DUNN FIELD
RECORD OF DECISION AMENDMENT

Defense Depot Memphis, Tennessee

Revision 3

January 2009

SOURCE AREAS GROUNDWATER REMEDY

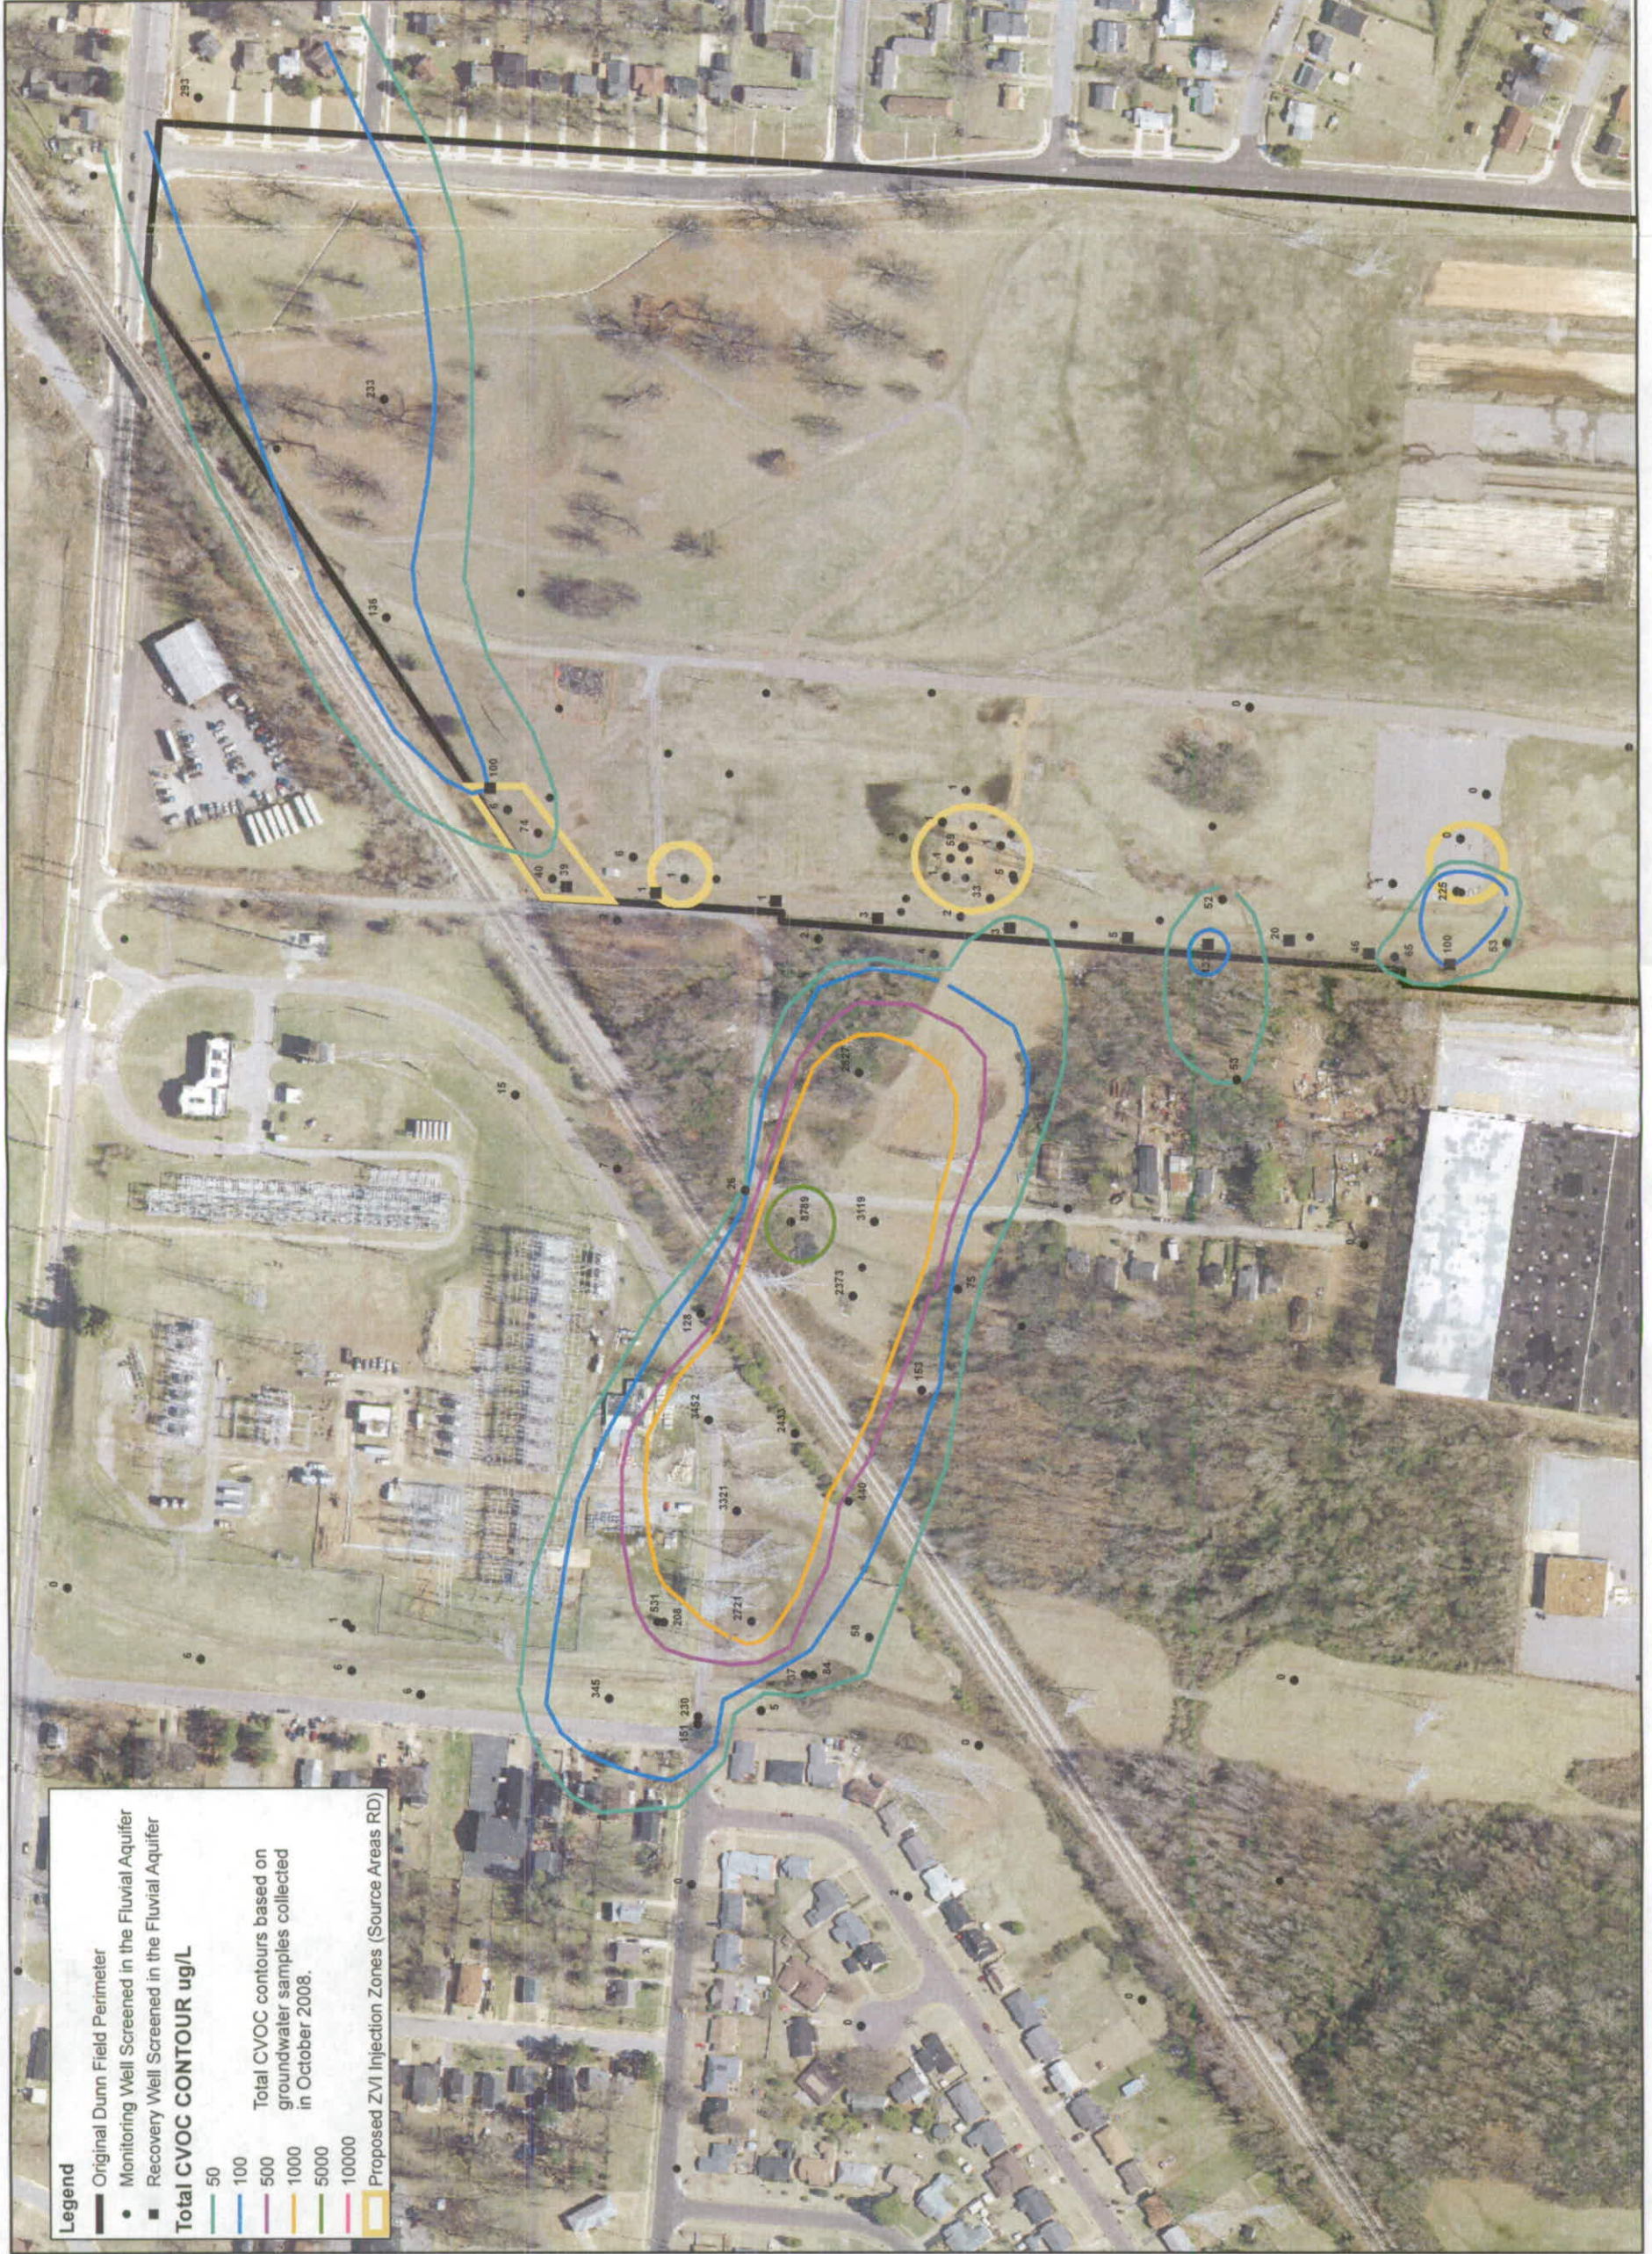
Based on the additional information, ZVI injections are recommended to be limited to source areas identified by the 1000 ug/L total CVOC contour and the loess treatment areas, which were the source of CVOCs in groundwater. The spacing between injection borings would be approximately 30 feet. The

CVOC plume outside the ZVI injection area will be treated by the Off-Depot groundwater remedy. The planned ZVI injection zones from the Source Areas RD are shown on Figure 6.
